JIM PETER LAN SURVEY
4759 CROSBY-COOK RD
ROME, OHIO 44085

Grading Plan Approved
as shown and/or noted
THOMAS P. GILLES, P.E.
Lake County Engineer
CJH Date 8/30/91

Reviewed and Accepted
LAKE COUNTY GENERAL HEALTH DISTRICT
Date 8/29/91
JOEL LUCHA, R.S., M.P.H.
Health Commissioner
BY *N. Niehus*

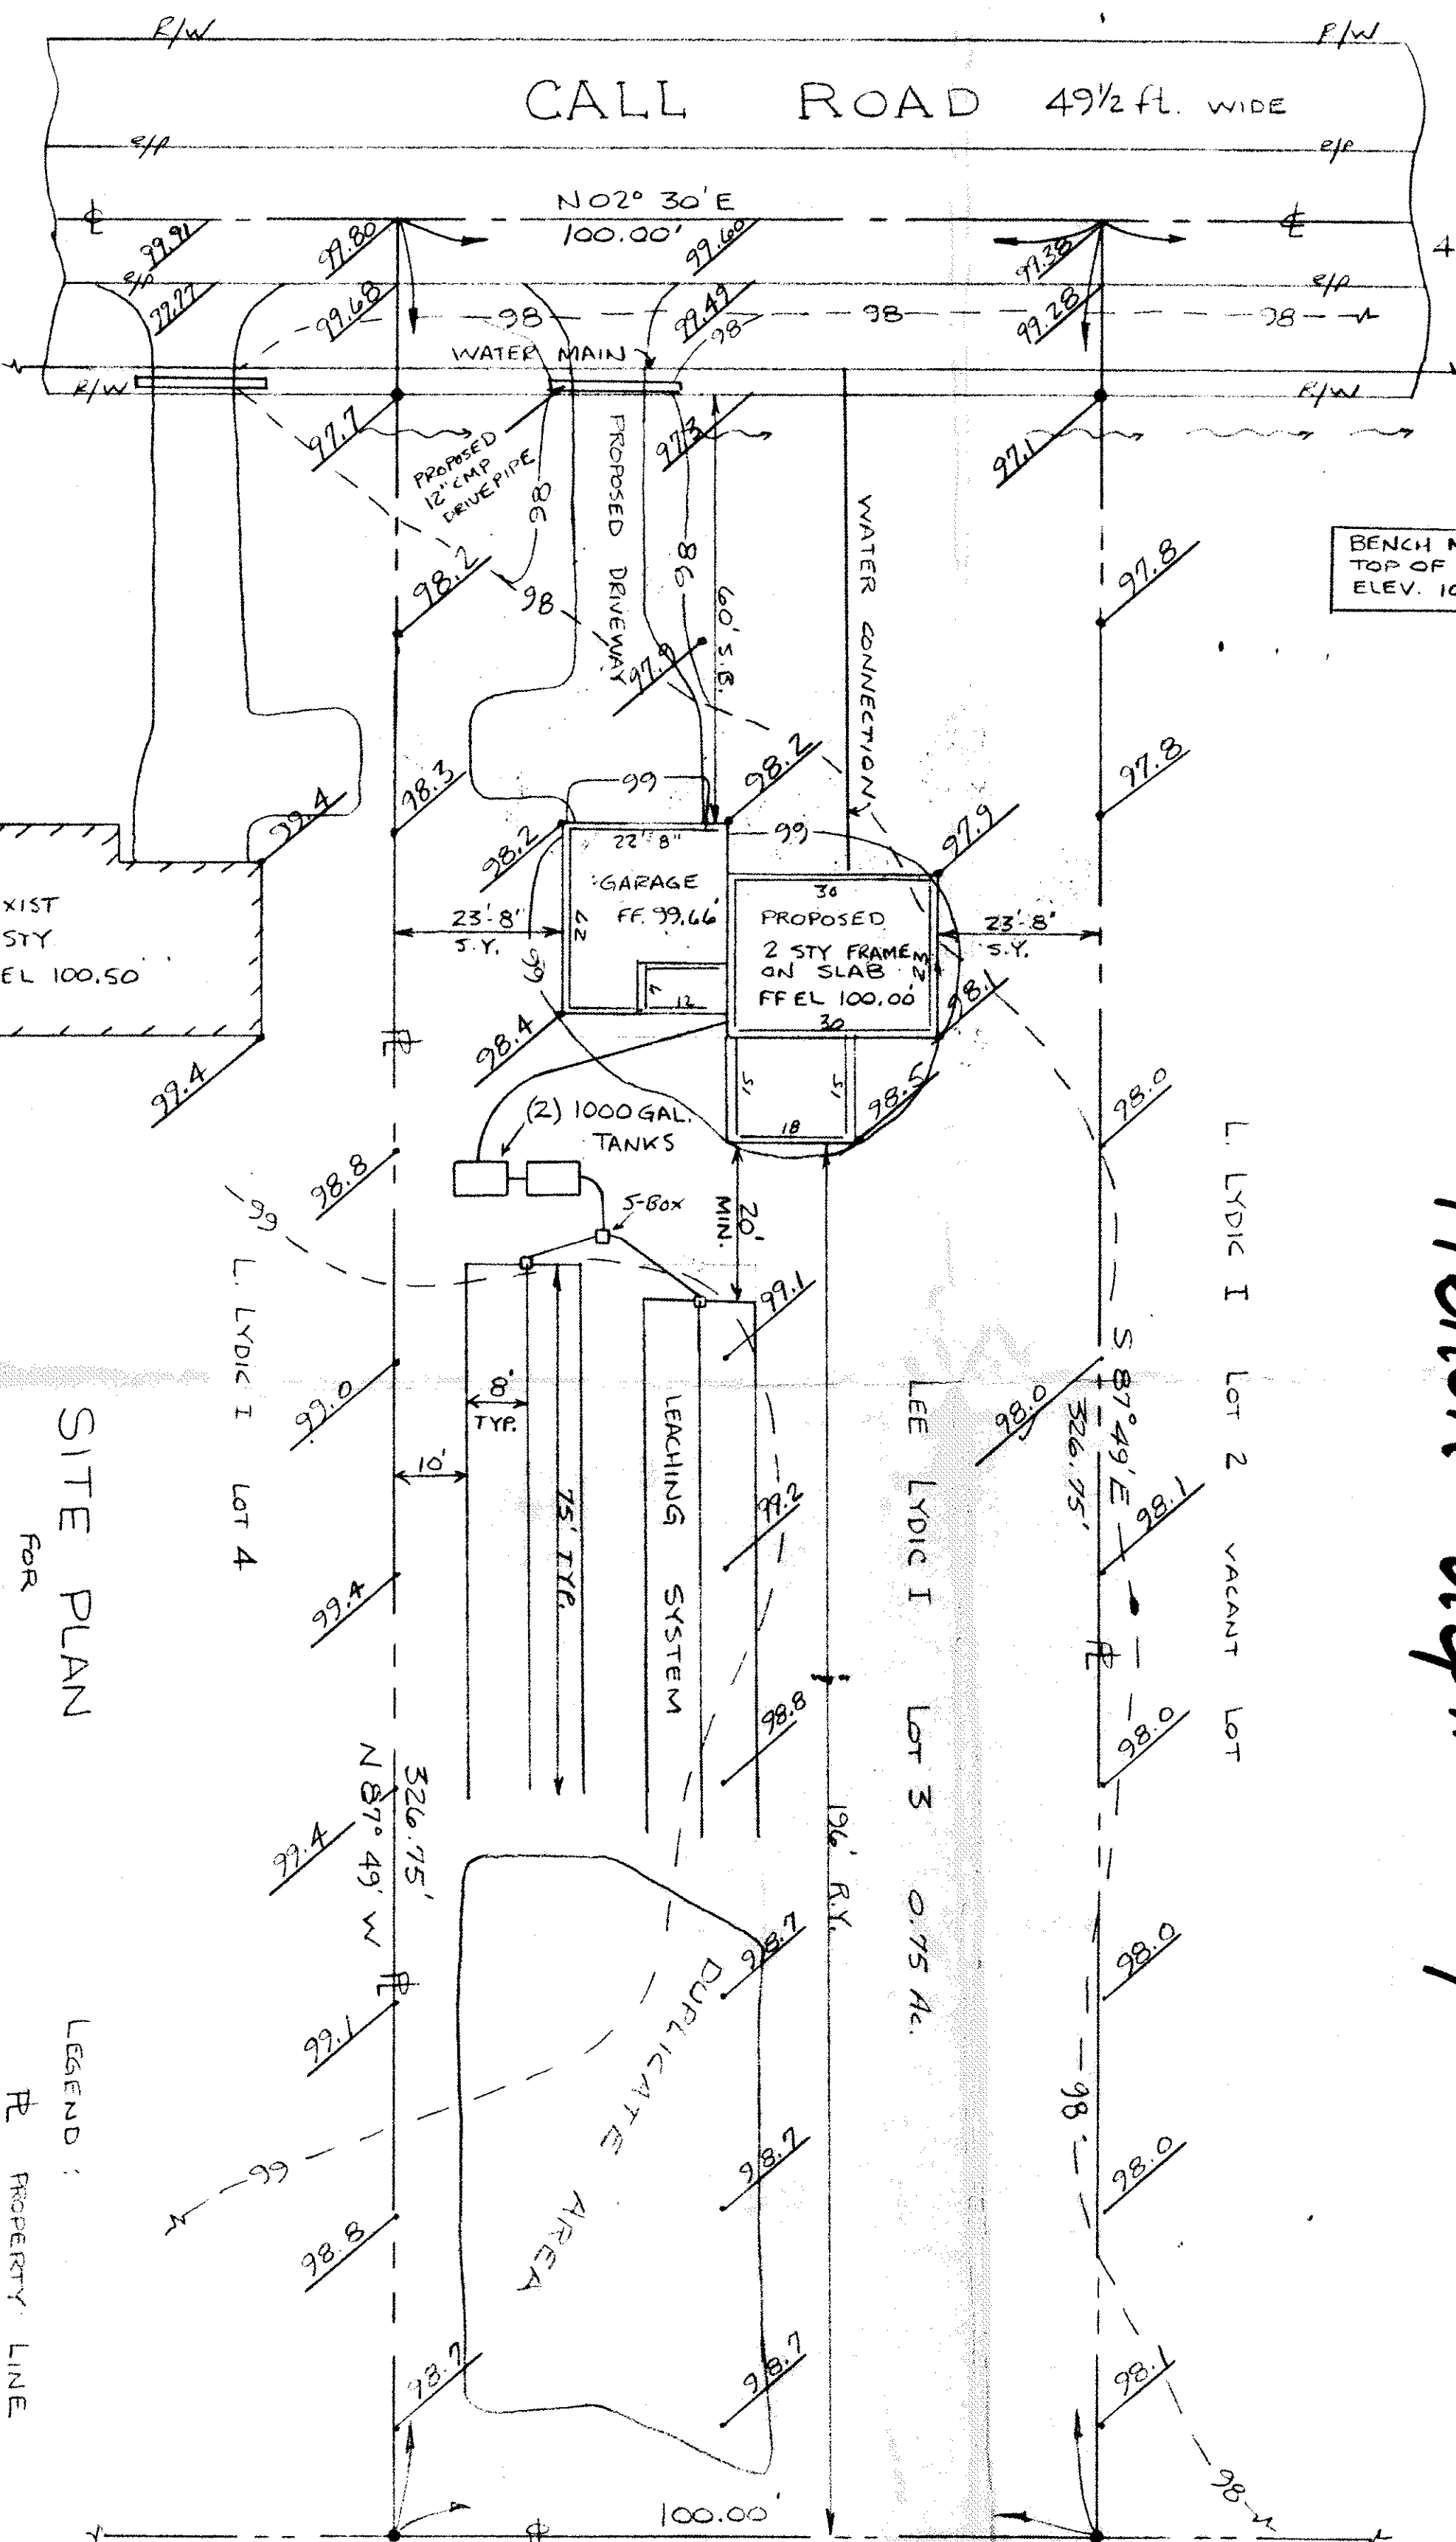
trench depth may not exceed 24"

- A. To be brought to finished grade
 - 1. Septic tank manhole covers
 - 2. Splitter box cover
 - 3. Distribution box cover
- B. No floor drains or downspouts to be discharged into septic tanks
- C. All waste water to be discharged into septic tanks
